SERVICE 		12
		X 89.100-26

THE IRON HORSE

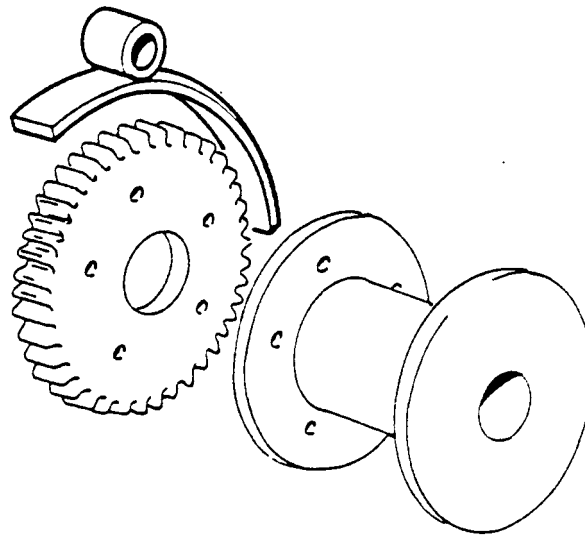
From serial number 100 some smaller modifications are made of the cable winch. The reason for these changes is to improve the safety and to increase the reliability.

Alteration A: The brake spring is secured with an extra washer and screw, which prevents it from jumping off the pin.

Alteration B: A cover is mounted over the big cable drum. The function of the cover is to prevent twigs and similar objects to get into the gearwheel. The cover can also be mounted on cable winch with the serial numbers 1-99. It is put on the outside of the cable wire.

The spare part number for the washer is: 531 00 11-17 and for the screw: 531 00 11-09

Spare part number: 531 00 04-24

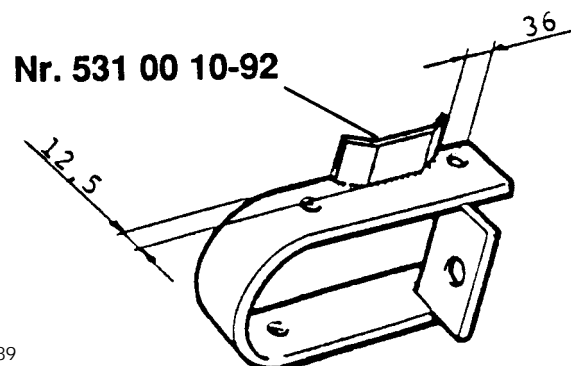
Loose drive track guides are available for mounting on the brake yokes. These guides prevent the drive tracks to run off and get stuck in the clutch forks. The drive track guides are welded on to the brake yoke, according to the illustration.

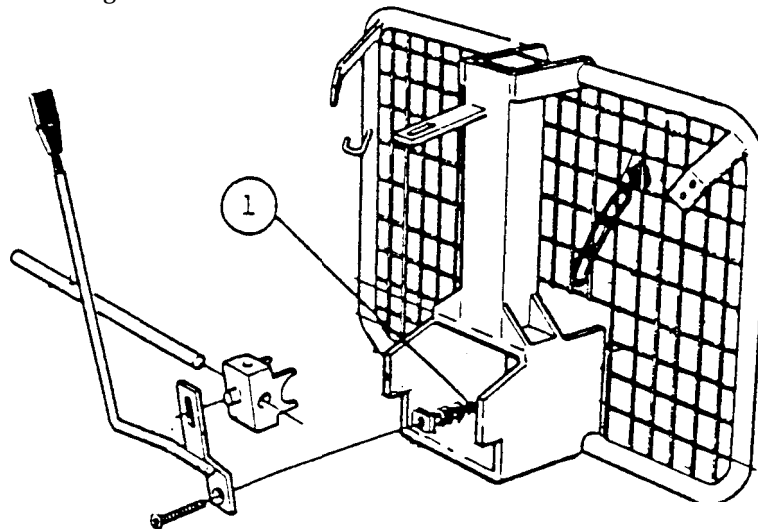
Adjustment of the gear shift lever: Tighten the nut (1) securely, so it will be impossible to lift off the gear shift lever from the pin on the gear shift fork.

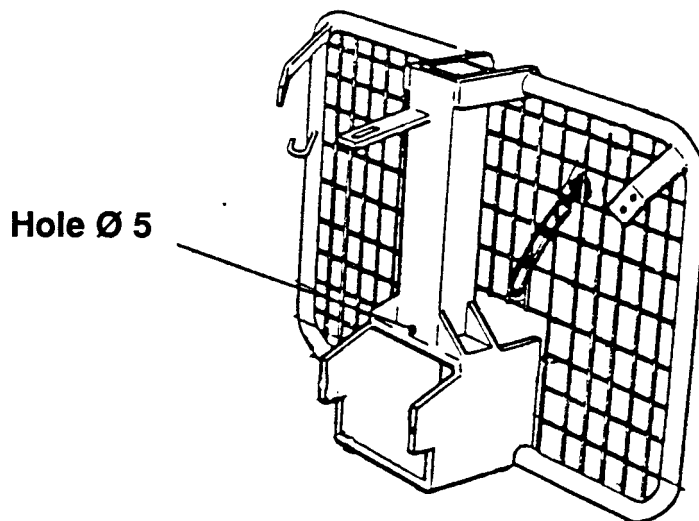
Drill a hole \varnothing 5 mm in the tower to drain water in the tube.

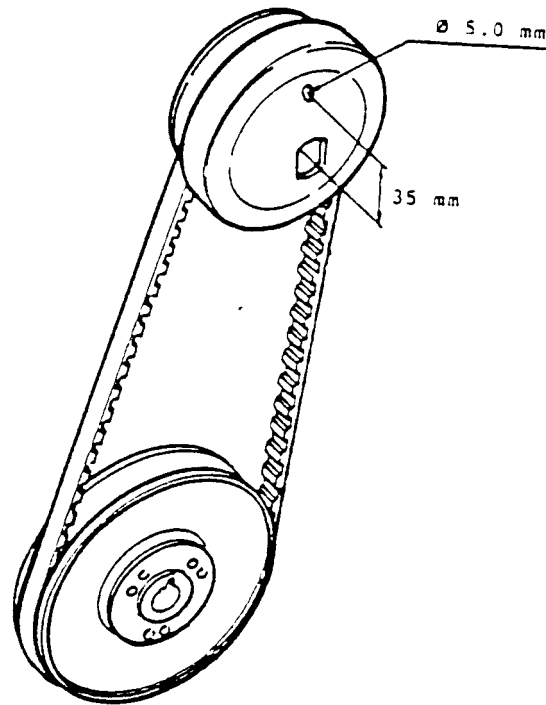
The primary variator has to be lubricated regularly in order to operate satisfactory. It is not necessary to remove the variator every time when lubricating, if a 05 mm hole is drilled according to the illustration. (See the Operator's Manual in the lubrication chapter).

This figure shows the engine with 3/4" motor axle

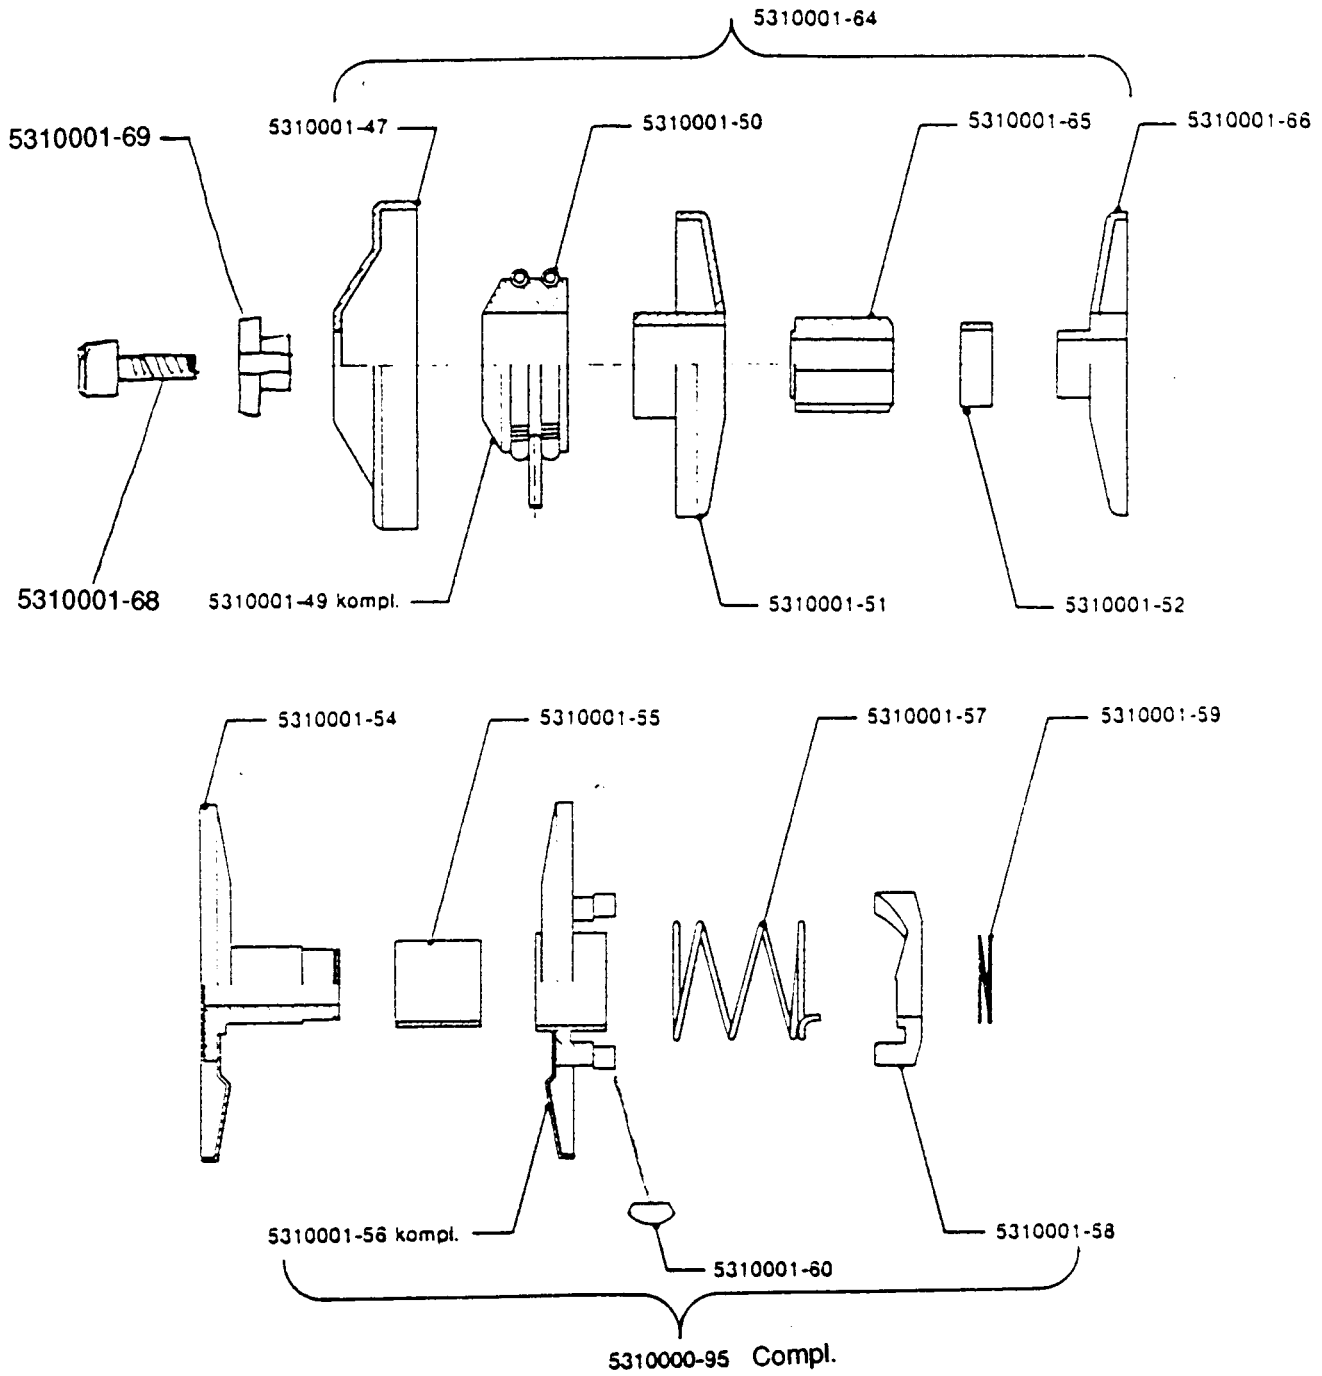
From serial number 0983948 the engine output shaft is 3/4" instead of 20 mm on the PRO, PIRAYA and STANDARD. The primary variator is changed in order to fit the new shaft. See the illustration.

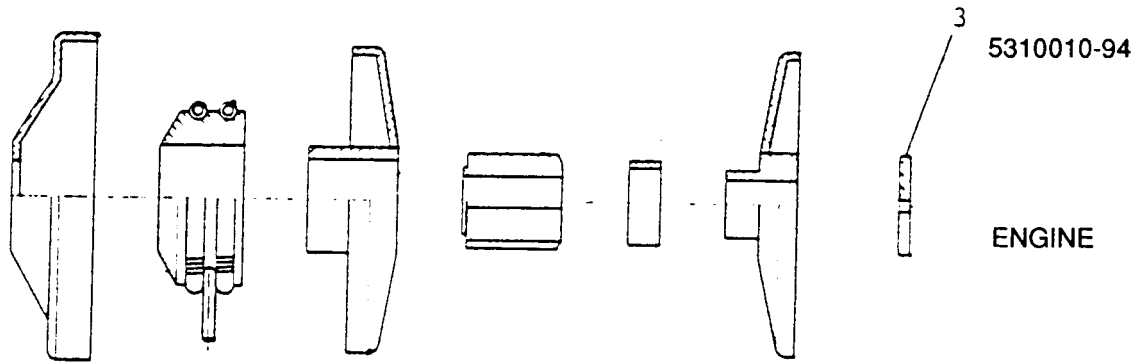
In order to unload the locking ring (1) on the secondary variator and to prevent it to be pushed off, the washer (2) should be mounted on the engine shaft, according to the illustration. A washer (3) should also be mounted on the engine shaft inside the primary variator so the belt runs straight.
